TRANSPORT ADDENDUM NOTE

**LAND WEST OF GATESMEAD
CREST NICHOLSON OPERATIONS LTD**

Transport Addendum Note

1.1.1 This Technical Note has been prepared by Ridge on behalf of the applicant in response to the comments raised by West Sussex County Council (WSCC) dated 2 July 2026, in its capacity as Local Highway Authority, on planning application DM/26/1315 for the proposed development of 49 homes at Land West of Gatesmead, Wickham Way, Haywards Heath.

Figure 3.1 – Traffic Survey Locations

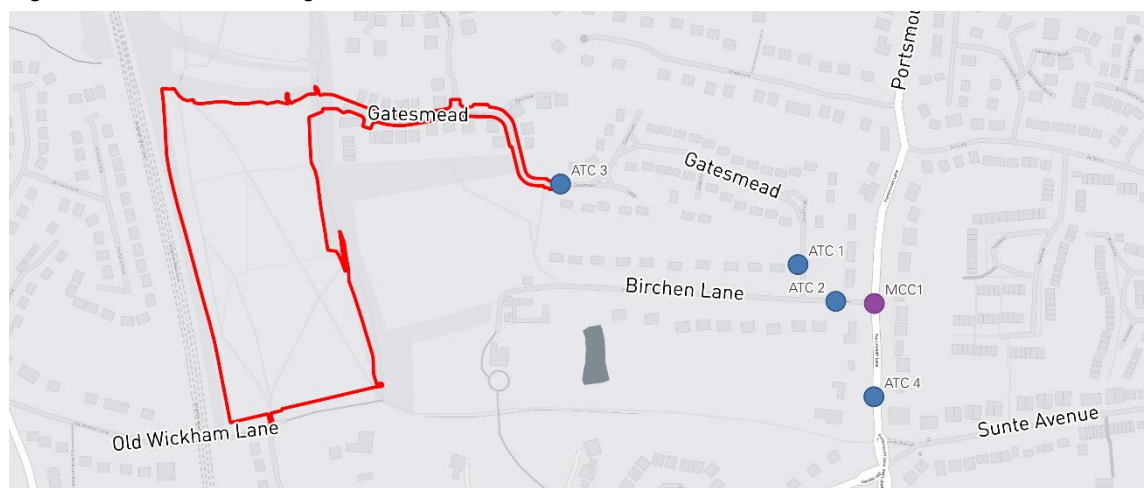
- 3.1.1 *“Embankments adjacent footways/carriageway with no safety margin to prevent falls. Auditor recommends providing safety margins. Designer states they will consider this at detailed design stage as form of separation (horizontal margin, grading, or barriers) will need considering depending on RPAs. Whilst the LHA agree details can be provided and agreed at detailed design, we advise designer to check and demonstrate that there is sufficient width to provide this at this stage.”*

- 3.1.2 Traffic surveys were undertaken in June 2025, including speed surveys ATC 1: Gatesmead and ATC 3: Gatesmead. The approximate location of the traffic surveys undertaken are shown in **Figure 3.1**.

- 3.1.3 A summary of the traffic survey data results is provided in **Table 3.1**. The raw traffic survey data is provided within the Transport Assessment.

DRAWING No: 5029426-RDG-XX-XX-DR-H-PL001-P07.dwg

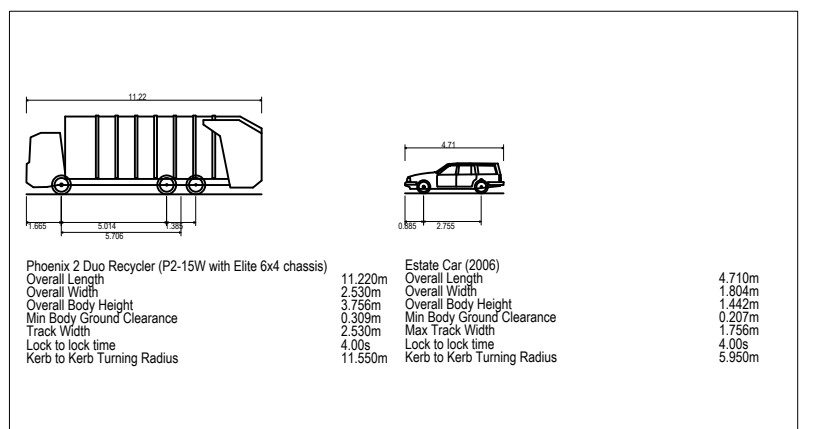
- 3.1.16 *“No footway on northern side between footpath and northern footway. Auditor states pedestrians will walk along verge/carriageway rather than cross road twice and advise an additional length of footway to link up (from PROW to northern side footway on Gatesmead). Designer states it is not feasible to provide footway on northern side in this location as this would require embankment widening which would encroach into woodland buffer and root protection areas. LHA advise further information and consultation with the LPA is undertaken on this point – what is the extent of the woodland buffer and root protection areas, what mapping has been used to ascertain that an embankment widening/footway here is not achievable?”*

3.1.7 Please see **Drawing 5029426-RDG-XX-XX-DR-H-PL001-P07** in **Appendix A**, which shows the updated access with an indicative fence line.

- 3.1.19 To minimise the likelihood of pedestrians continuing along the verge, fencing is proposed at the footway termination point to guide pedestrians towards the proposed crossing point. Please see **Drawing 5029426-RDG-XX-XX-DR-H-PL001-P07** in **Appendix A**.

DRAWING No: 5029426-RDG-XX-XX-DR-H-PL007-P01.dwg

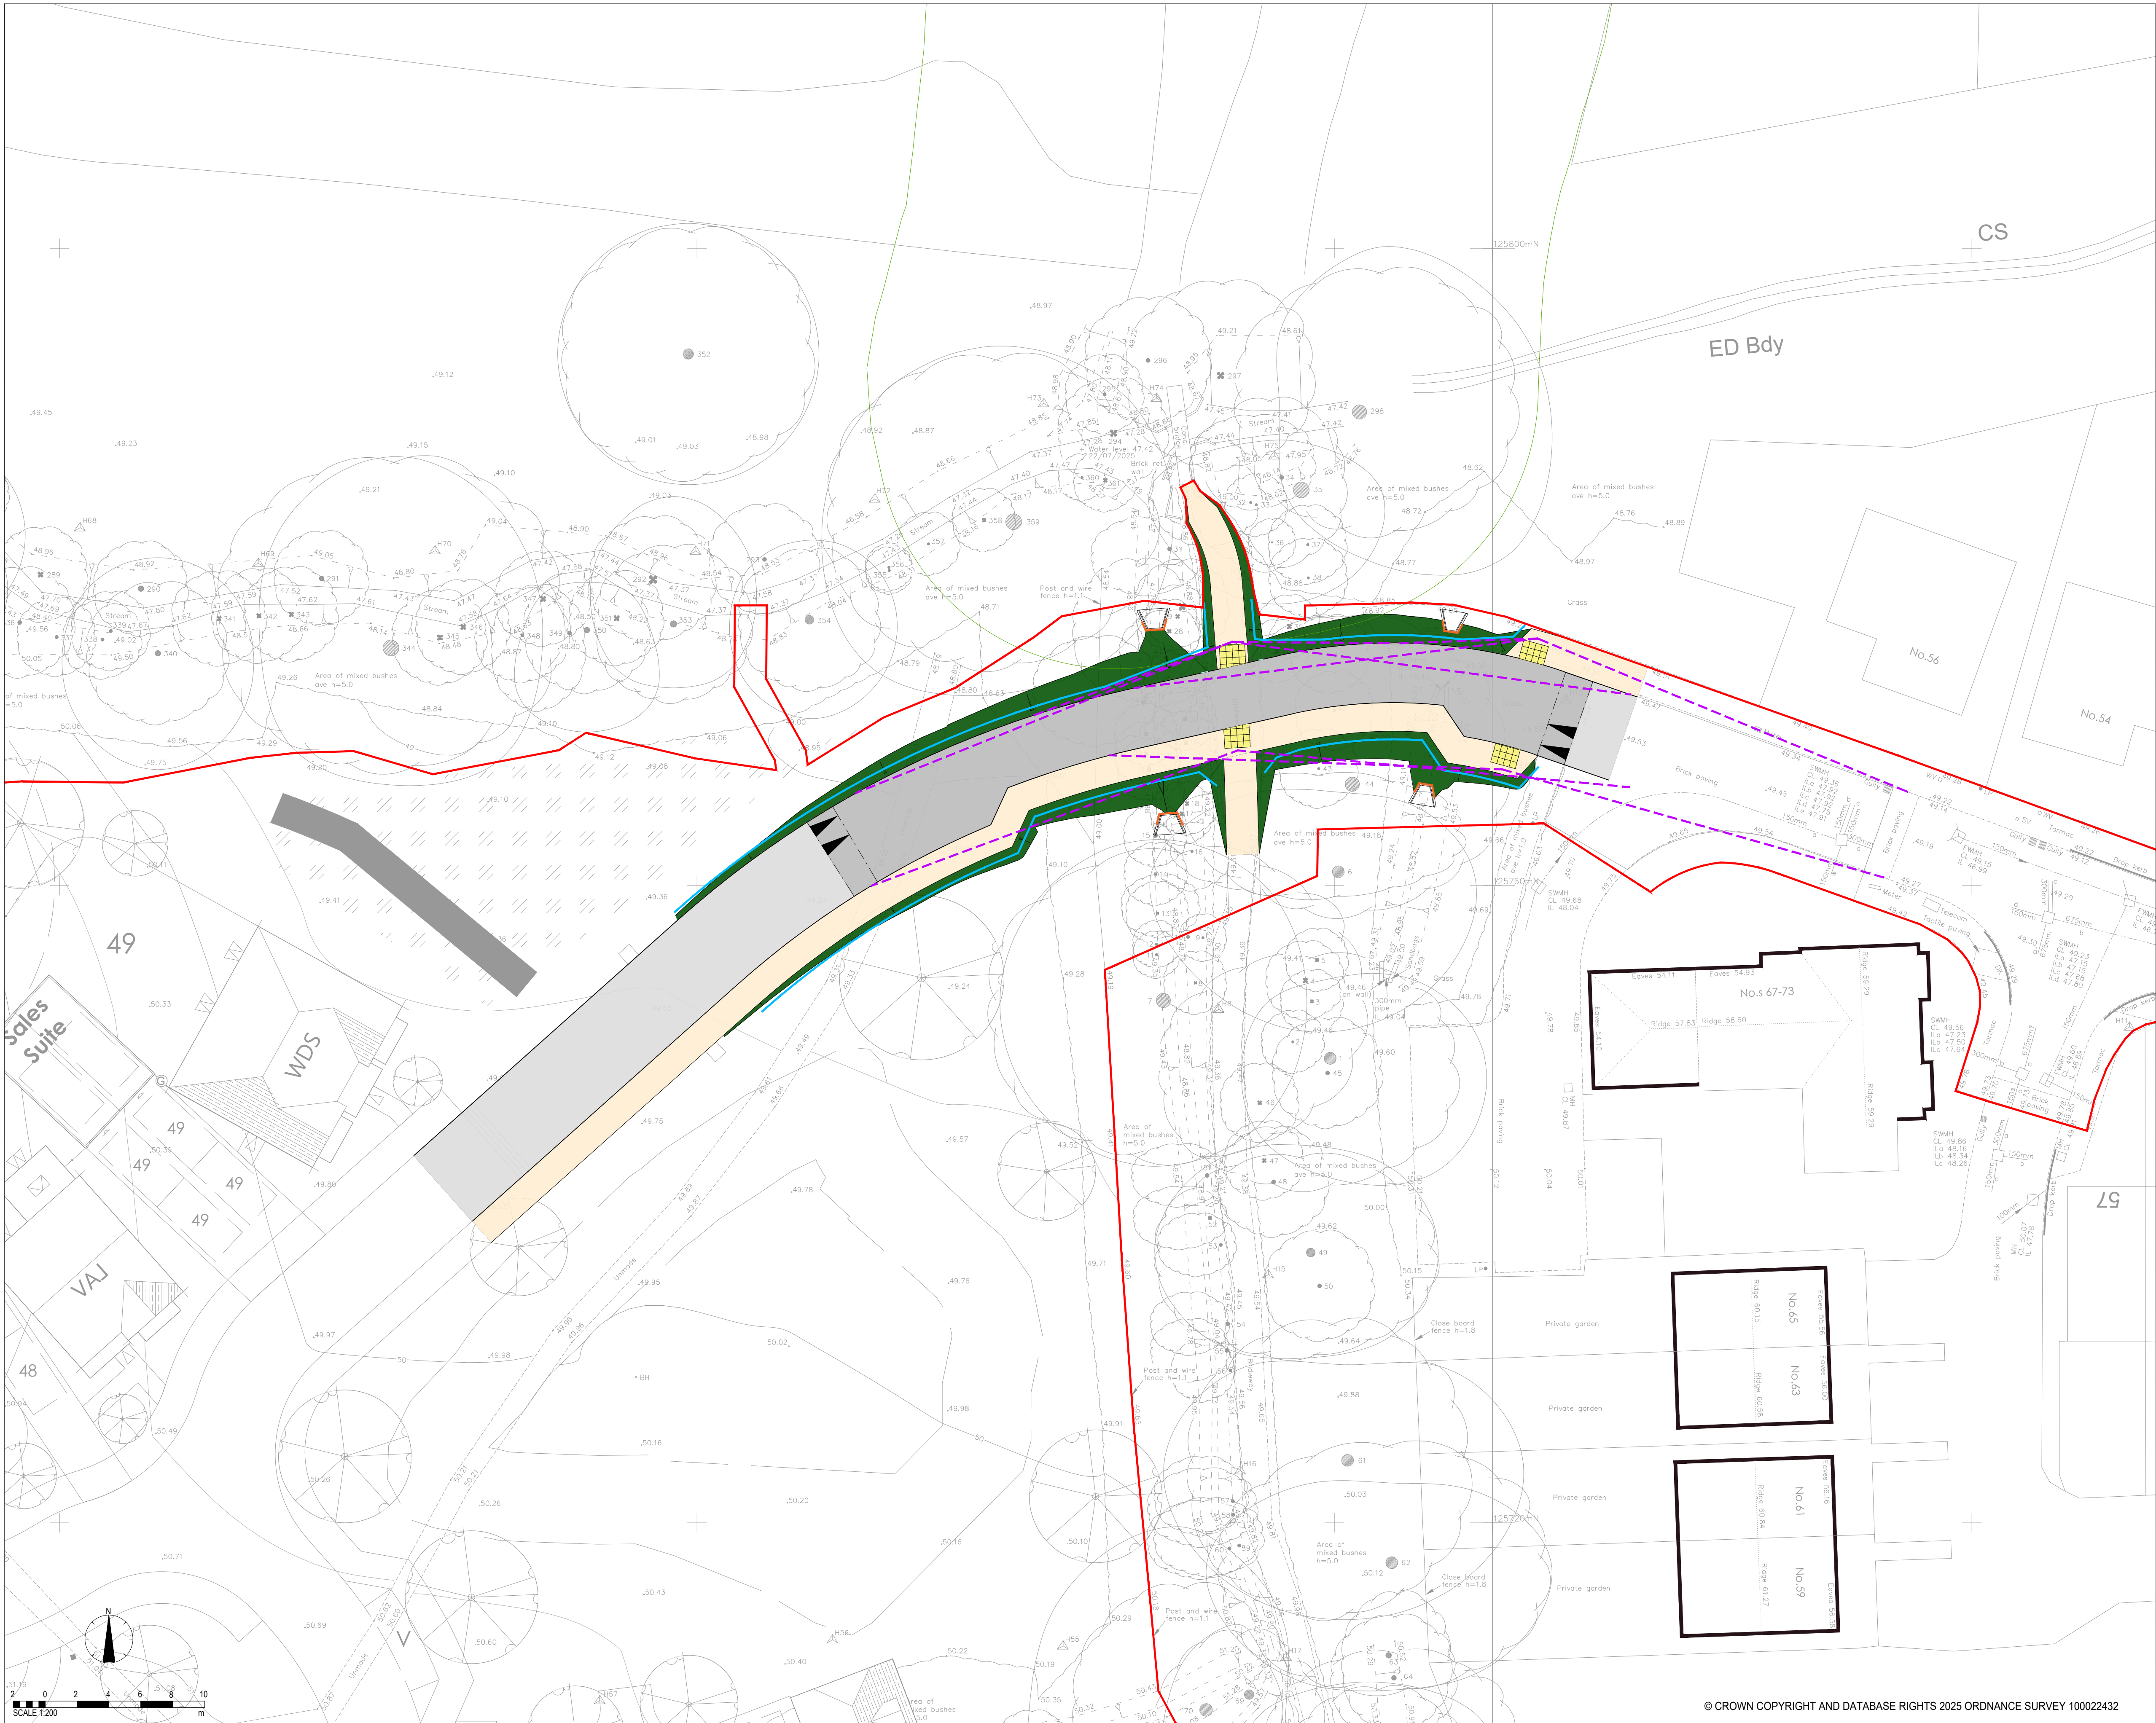
- 3.1.10 *“Narrowing on inside bend – no visibility splays showing vehicles approaching narrowing can see opposing vehicles on inside bend in both directions. Auditor advises providing forward visibility splays over adopted land. Designer states blue visibility splay line shows 25m SSD (for 20mph) to carriageway narrowing in both directions in advance of give way lines. This will be further reviewed at Detailed Design stage. Whilst LHA agree, designer should confirm that land this passes through will be adopted highway/ applicant maintained.”*

- 3.1.12 *“Forward visibility splay on Gatesmead for vehicles approaching from east appears to extend to private land. Auditor advises splay amended so does not extend through private land. Designer has clarified that splay passes through land under the applicant control thus ongoing maintenance can be given. Whilst LHA agree, it would be useful for extent of adopted highway land for adjoining site to be provided.”*

- 3.1.11 The land through which the visibility splay passes, is proposed to be adopted. **Drawing 5029426-RDG-XX-XX-DR-H-PL007-P01** in **Appendix B** indicates the minimum extent of land proposed for adoption, which includes the visibility splays.

- 3.1.13 The visibility splays are within land under the applicant’s control or within the carriageway of existing Gatesmead. The existing sections of Gatesmead are currently subject to the adoption process, and the proposed extent of this adoption, together with the land within the applicant’s control, is shown on **Drawing 5029426-RDG-XX-XX-DR-H-PL007-P01** in **Appendix B**.

DRAWING No: 5029426-RDG-XX-XX-DR-H-PL006-P05.dwg

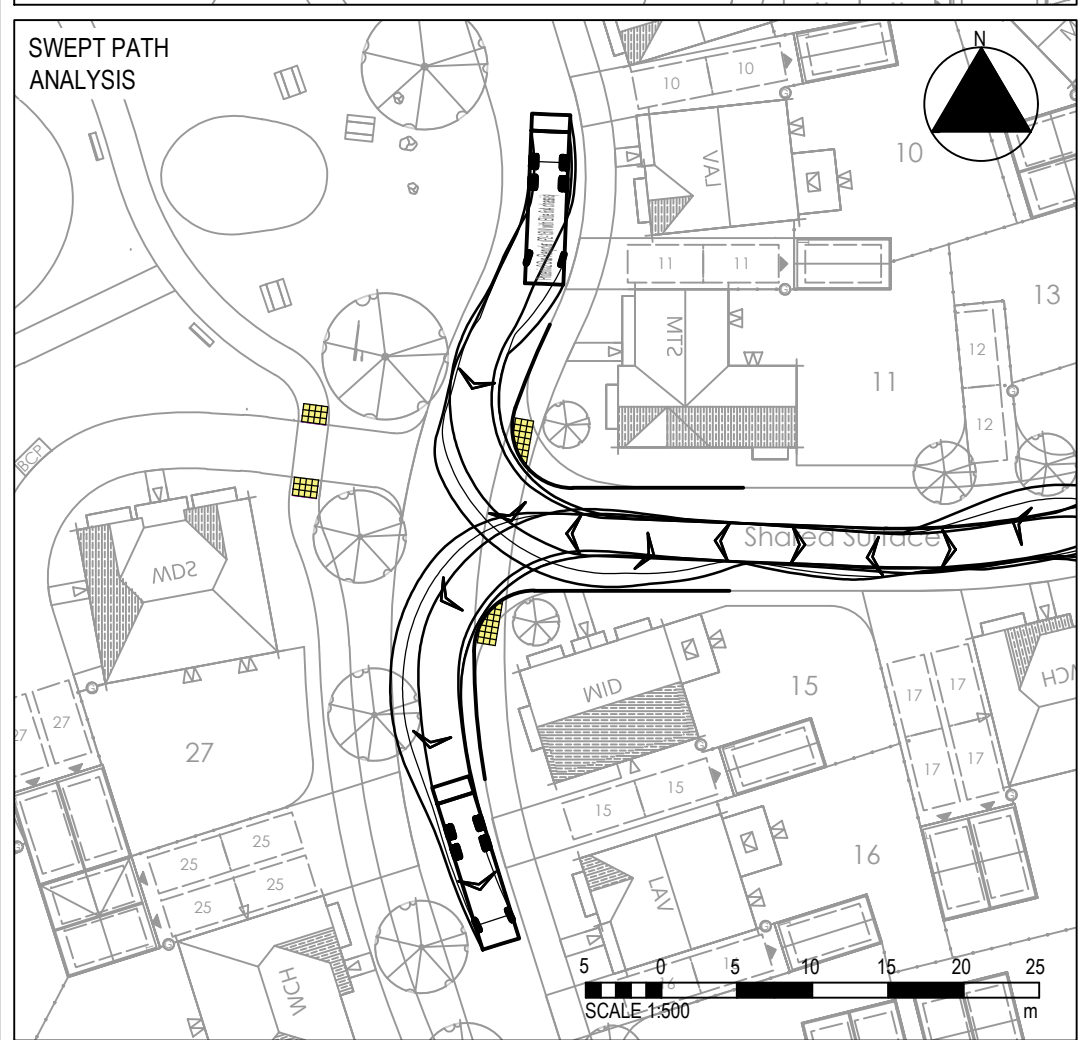
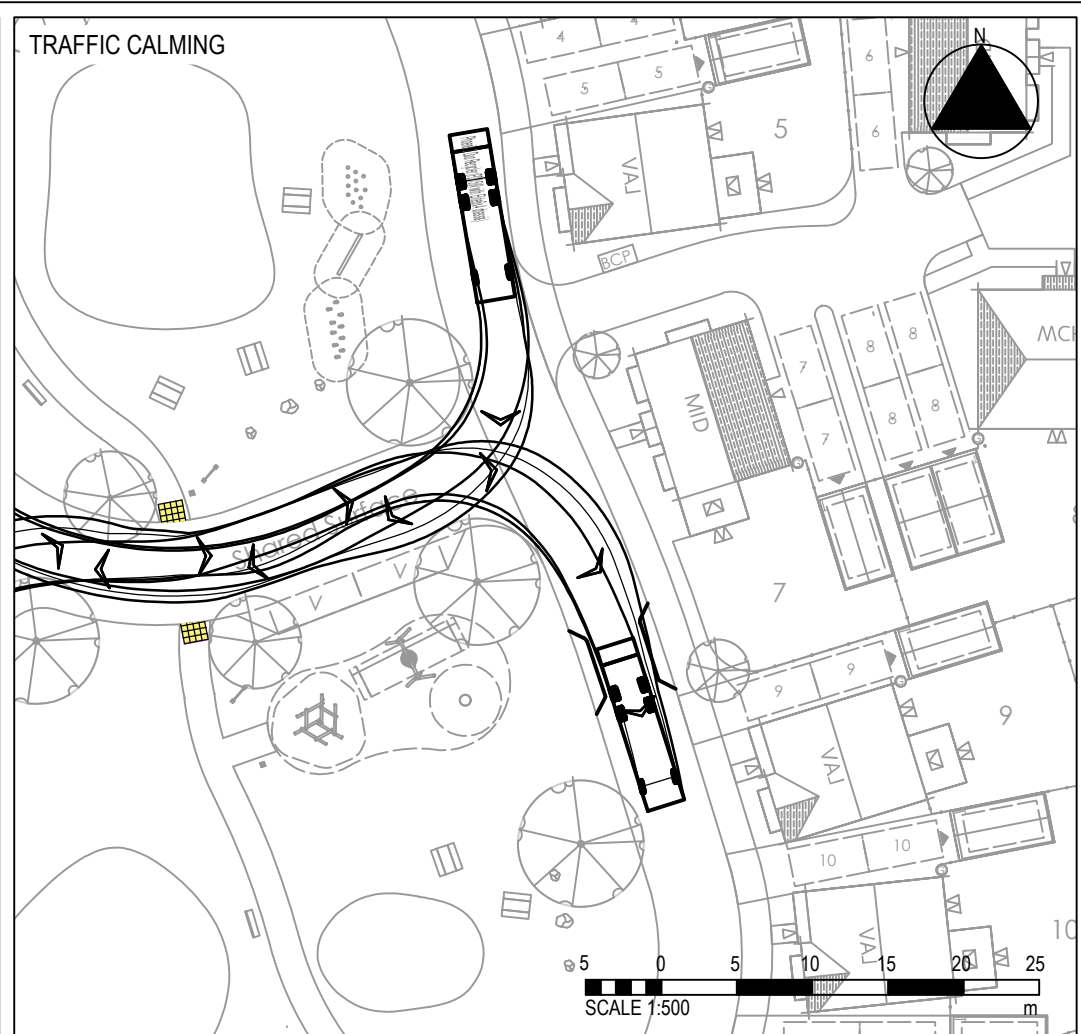
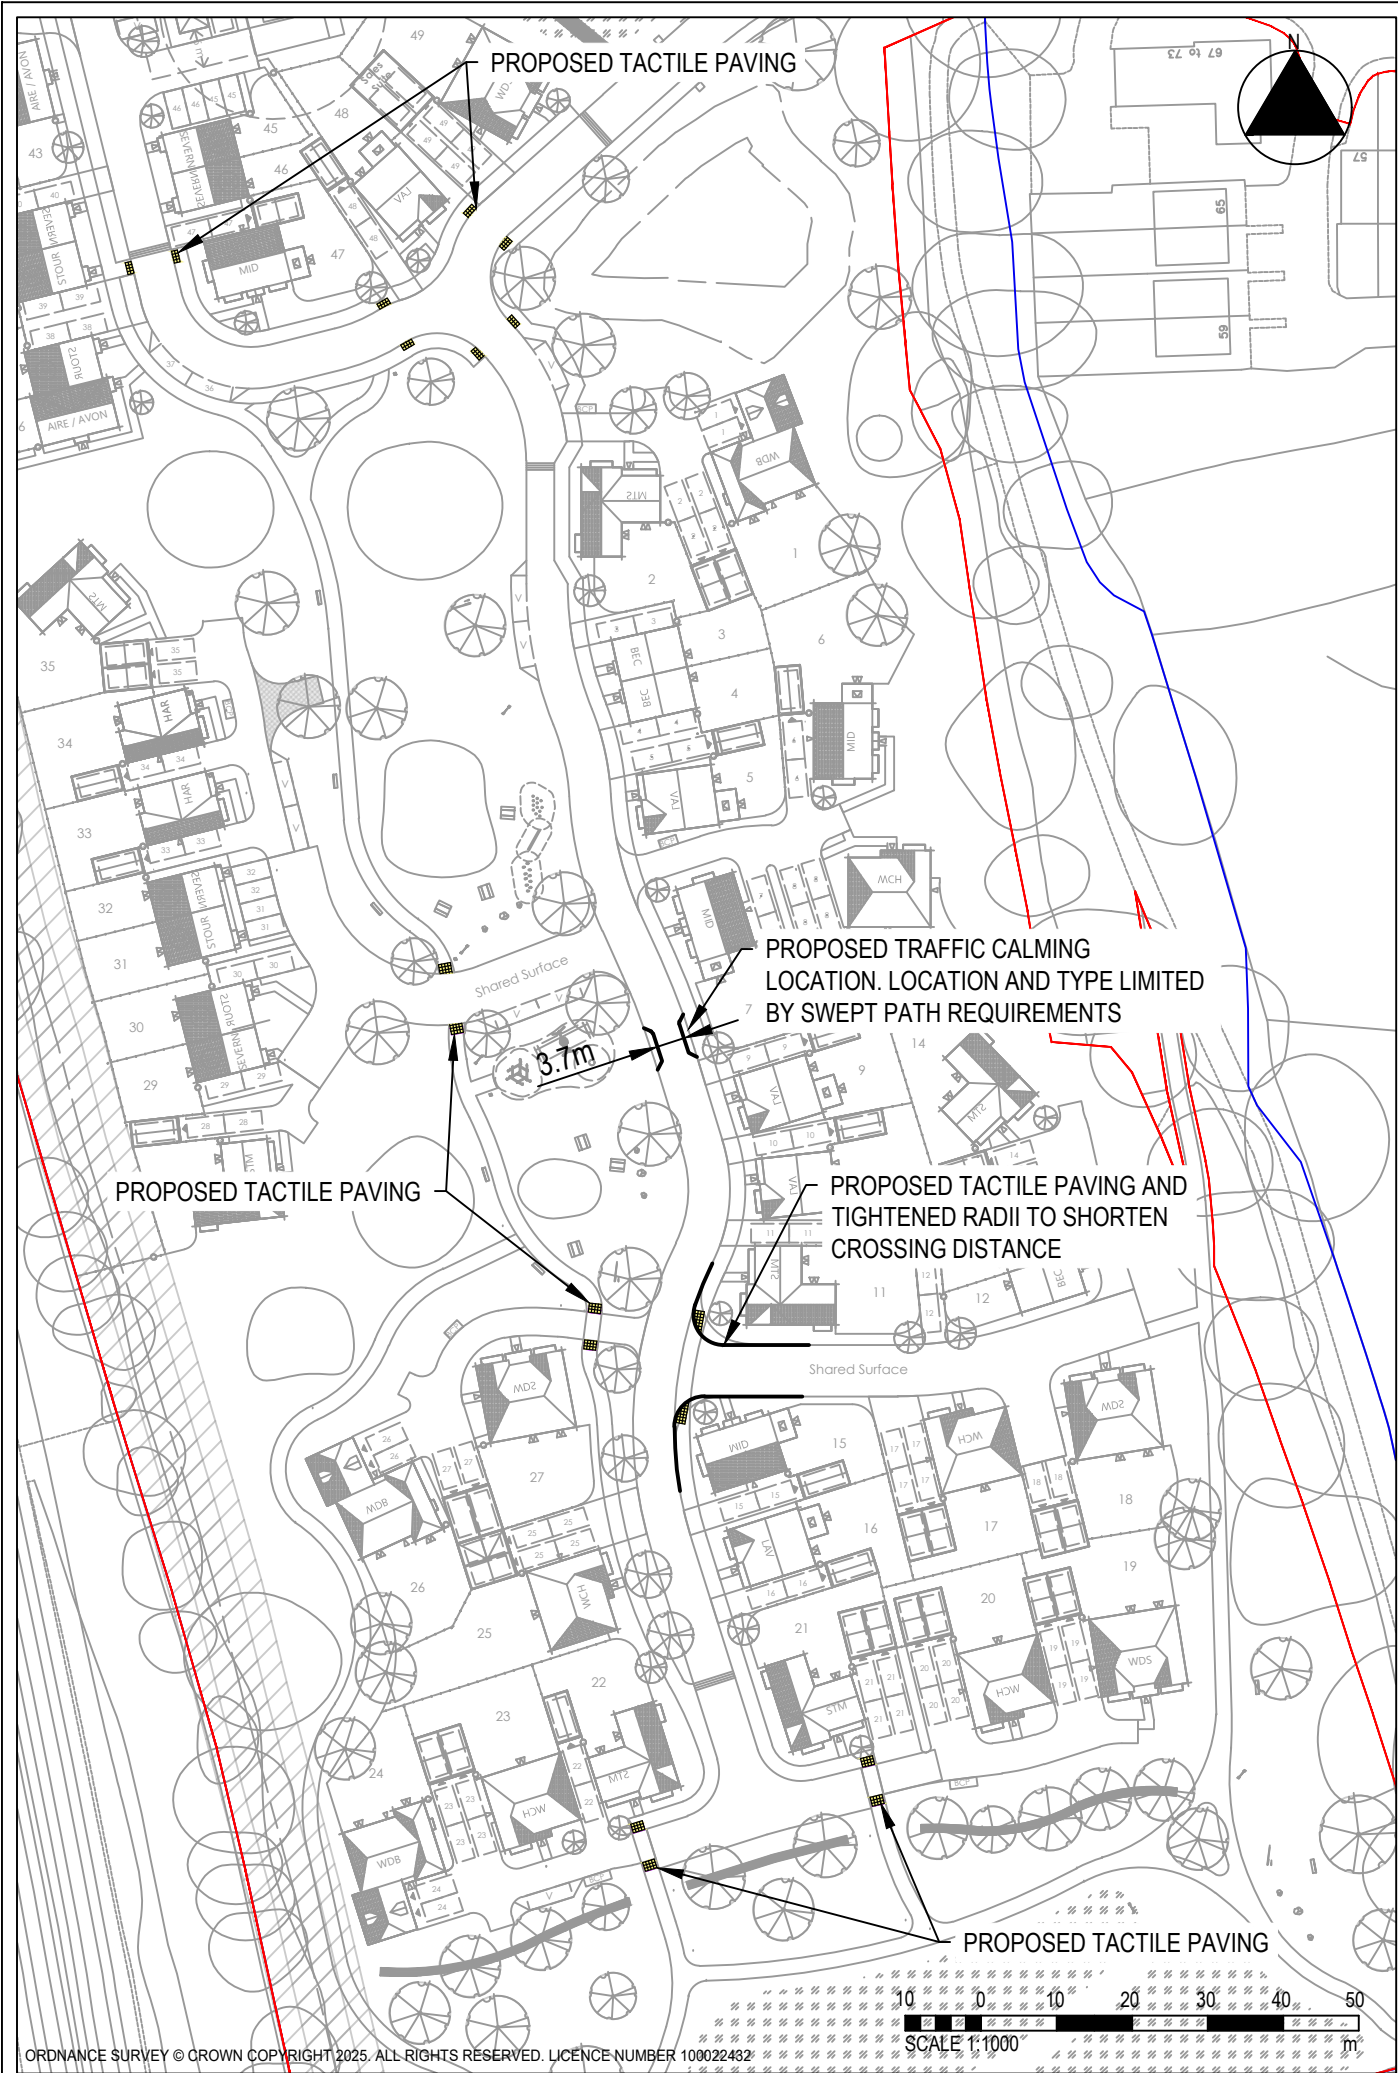
- 3.1.14 *“Pedestrian crossing points without visibility splays, those shown are not to standard (X distances 0.8m and 1.2m) which will result in inadequate visibility of oncoming vehicles for pedestrians crossing. Auditor advises appropriate visibility splays demonstrated where these can be maintained. Designer has stated that splays have been demonstrated at ‘x’ distance of 1.2m yet auditor has already stated this is not to standard. A minimum 1.5m ‘x’ distance should be used. Please amend splays and response accordingly.”*

- 3.1.15 Pedestrian visibility splays have been reviewed and amended to apply a minimum ‘x’ distance of 1.5m at the relevant uncontrolled crossing points. These are shown on revised **Drawing 5029426-RDG-XX-XX-DR-H-PL006-P05** which are in **Appendix C**. The revised arrangement demonstrates the visibility available between pedestrians waiting to cross and approaching vehicles.
